Traffic Calming (Speed Humps) - Brookview Drive

Date: May 6, 2024

From: Director, Traffic Management, Transportation Services

Attachment 2: Speed Hump Locations Plan - Brookview Drive

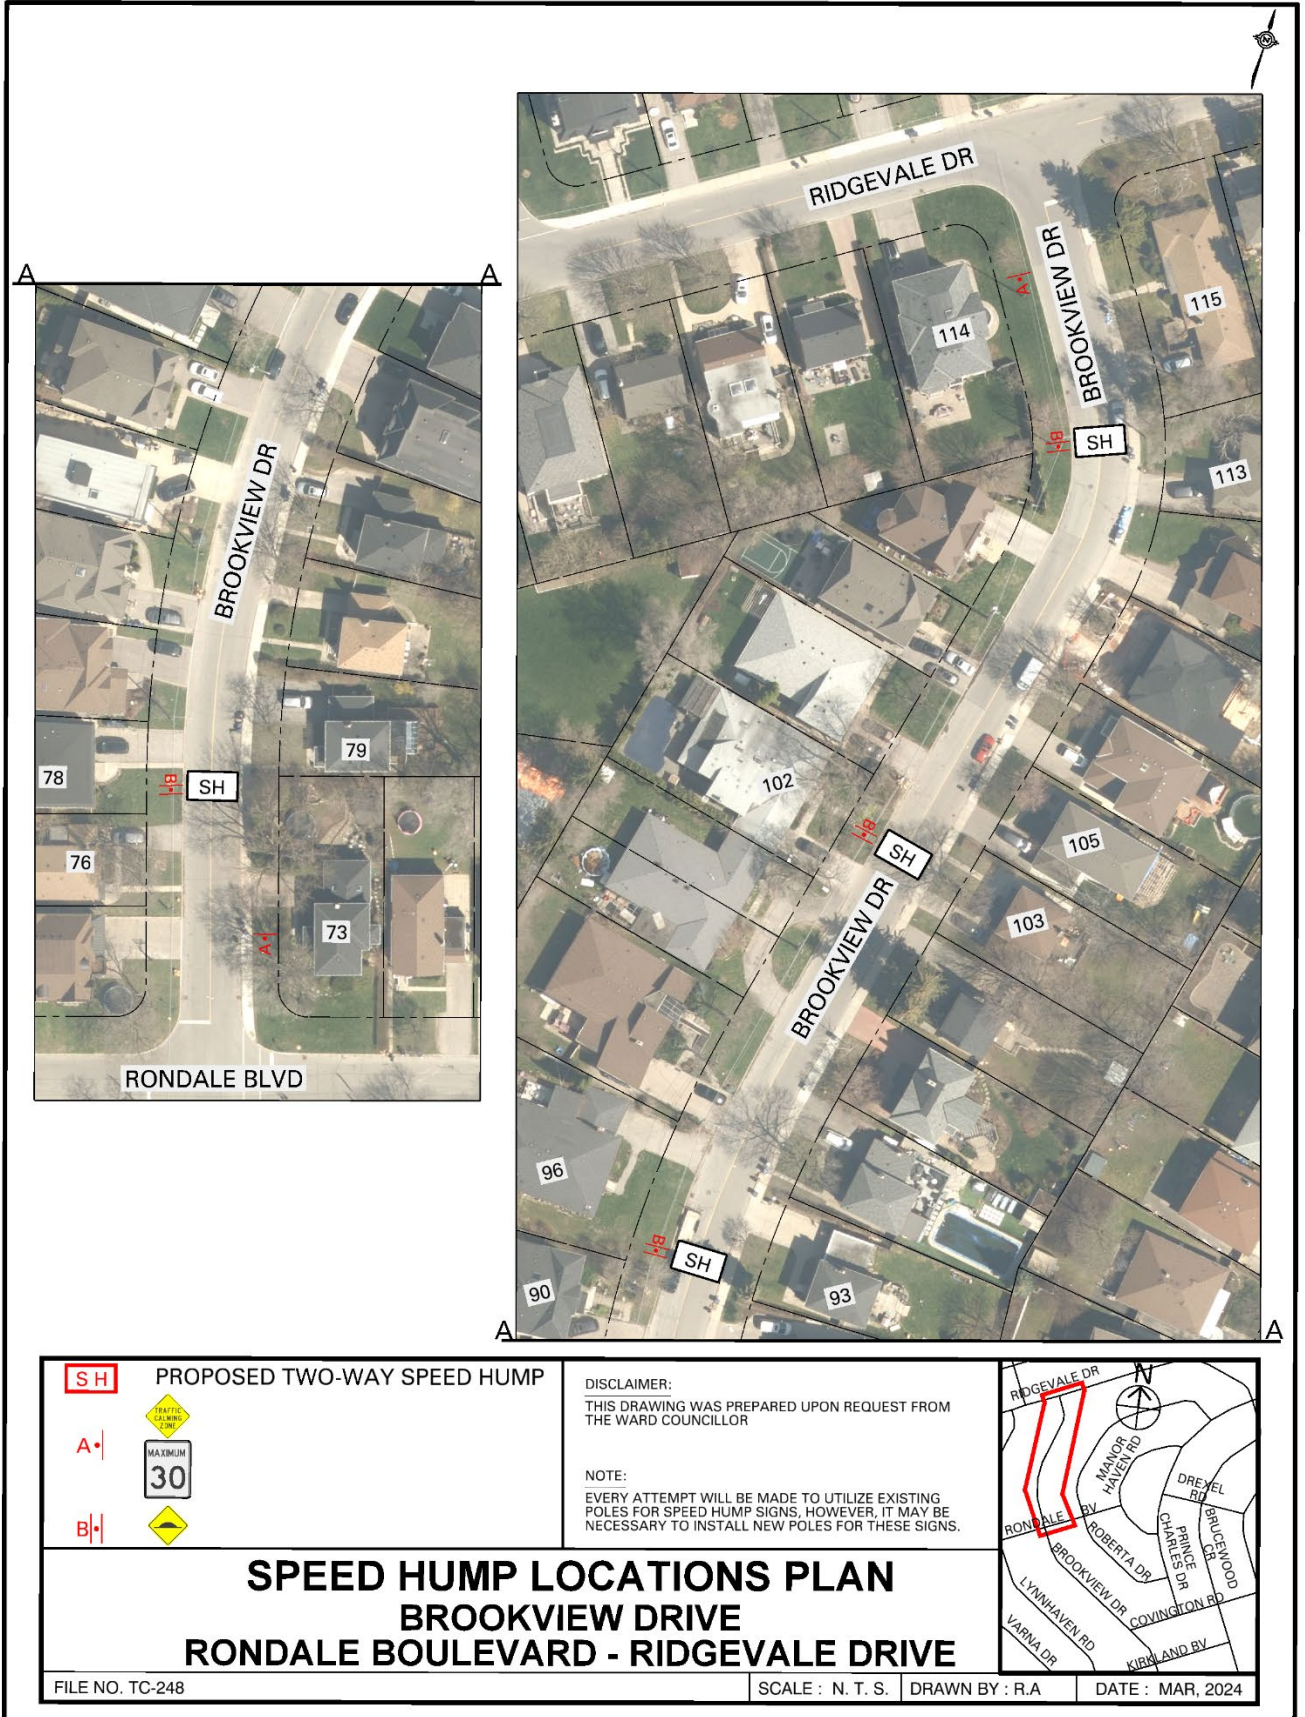
Brookview Drive appears to primarily service the residents that reside on the roadway and would not impact response times for other community members. It is important that the applicant understand that the installation of traffic calming devices will reduce the speed that emergency vehicles travel when responding to emergencies on roadways where they are installed.

Toronto Fire Services does not support this proposed speed hump installation as it may negatively impact service delivery. The physical restrictions imposed by speed humps have a greater impact on fire vehicles. Response time increases with every obstacle encountered responding to any emergency incident and the cumulative impact of several speed humps can increase responses times.

Toronto Fire Services is supportive of initiatives that improve safety for all citizens of and visitors to the City of Toronto. However, careful consideration must be given to accepting a delay to emergency response vehicles as a compromise to combat the risks presented by all vehicular traffic. Our recommendation is that non-physical measures be considered and evaluated to determine if desired results can be obtained without imposing a physical obstacle to emergency vehicles.
